PR/1095/22

Record of Executive Business and Chief Executive's Order

Reg. Reference: SDZ21A/0022 **Application Date:** 02-Dec-2021
Submission Type: Significant **Registration Date:** 29-Jun-2022
Additional
Information

Proposed Development: The construction of 569 dwellings, a creche, innovation hub and open space in the Clonburris South West Development Area of the Clonburris SDZ Planning Scheme 2019 as follows: 173 houses comprising 8 two bedroom houses, 153 three bedroom houses and 12 four bedroom houses (147 dwellings in CSW-S4 consisting of 8 two bedroom houses, 127 three bedroom houses & 12 four bedroom houses & 26 three bedroom dwellings in CSW-S3}, all 2 storey comprising semi-detached, terraced, end terrace units (with parking and private open space); (B) 148 duplex apartments/apartments {88 in CSW-S4 & 60 in CSW-S3} comprising 74 two bedroom units and 74 three bedroom units, in 16 three storey buildings. In CSW-S4 Duplex Blocks A,B,C,D,E,F,G,J,K, comprise 8 units (4 two bed & 4 three bed units), Duplex Block H comprises 16 units (8 two bed & 8 three bed units), In CSW-S3 Blocks L, N & O comprise 8 units (4 two bed & 4 three bed units), Block M comprises 14 units (7 two b

Figure 1- Overall Street layout proposed

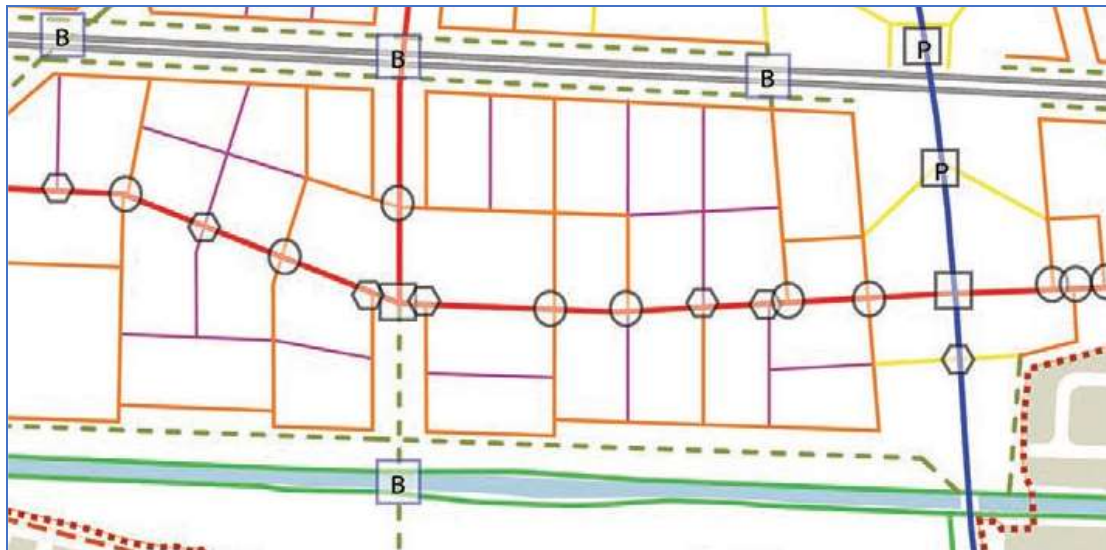
The Roads Section outline that the subject site's internal street layout has been designed with several junctions and a meandering alignment through the development to promote traffic calming. The overall street layout does not match the Planning Scheme. The NTA has recommended removal of access junction to street 3, to promote walking and cycling. The other

access and road layout should conform to the Movement Concept. The Roads Section outlines that a three-way junction at the south of street 3 (shown in Figure 3) should be restored to allow the open flow of traffic around the development in accordance with the transport assessment and strategy that accompanies the Planning Scheme.

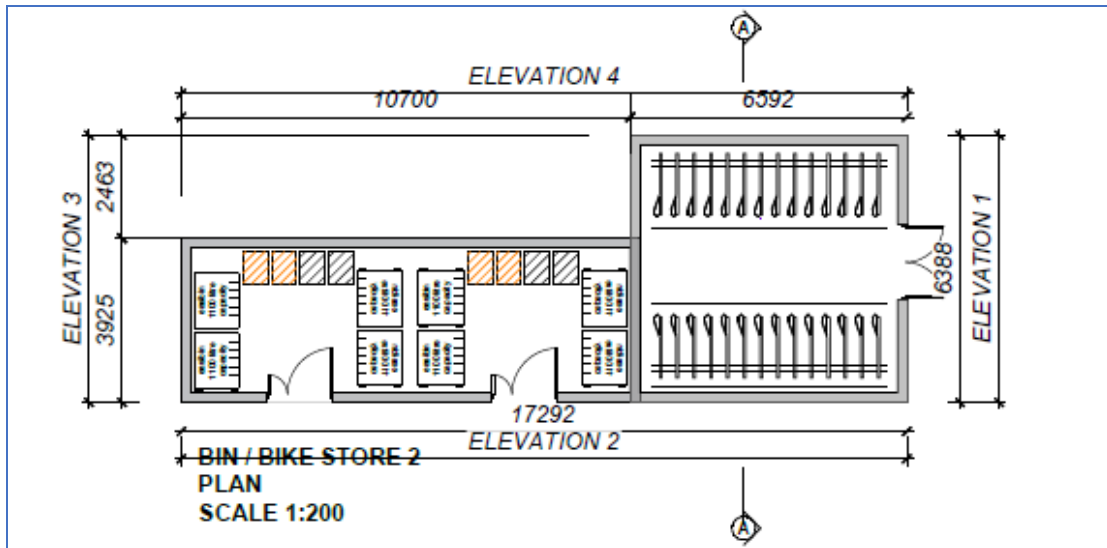
In this context, the Planning Authority has concerns in relation to the approach of the proposed development to car parking. It appears from the site layout plan and the taking in charge drawings that the majority of car parking is in-curtilage. The Scheme states that parking within Home Zones/ Intimate Local Streets shall be on- street. Further consideration of the approach to car parking is required by way of further information. This issue is interlinked with the design of the public realm. Noted that the Parking Strategy in the Transport Assessment and Strategy examined the spatial requirement for residential on-street parking, concluding that maximum parking standard provision could be met on-street with only a few areas requiring supplementary parking.

Figure 4 road without turning point

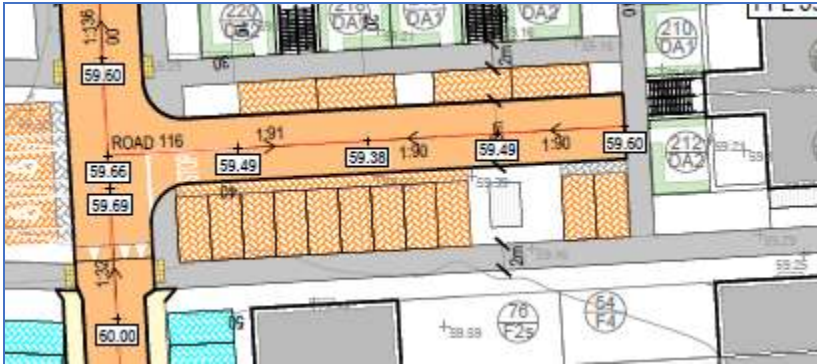
Figure 5 no turning point provided.

The main internal access roads are designed in accordance with the Design Manual for Urban Roads and Streets (DMURS) and Local Authority taking in charge requirements. The applicant should ensure that turning manoeuvres are achievable on all roads unless short enough to allow reversing as per DMURS (see Figure 4 and Figure 5 below). Consideration should be given to the priority of the road being reversed onto.

Figure 8 Refuse turning

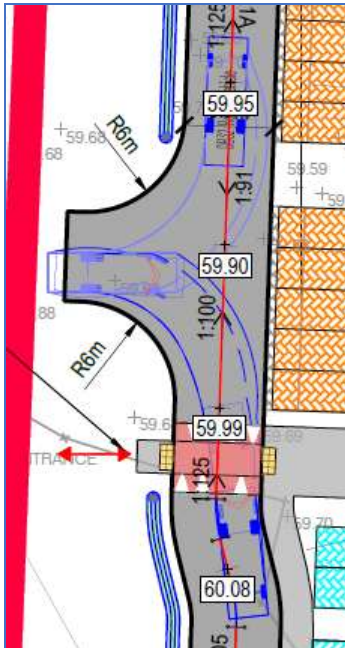
An overall layout highlighting the refuse collection strategy for the apartment blocks and duplex areas is required.
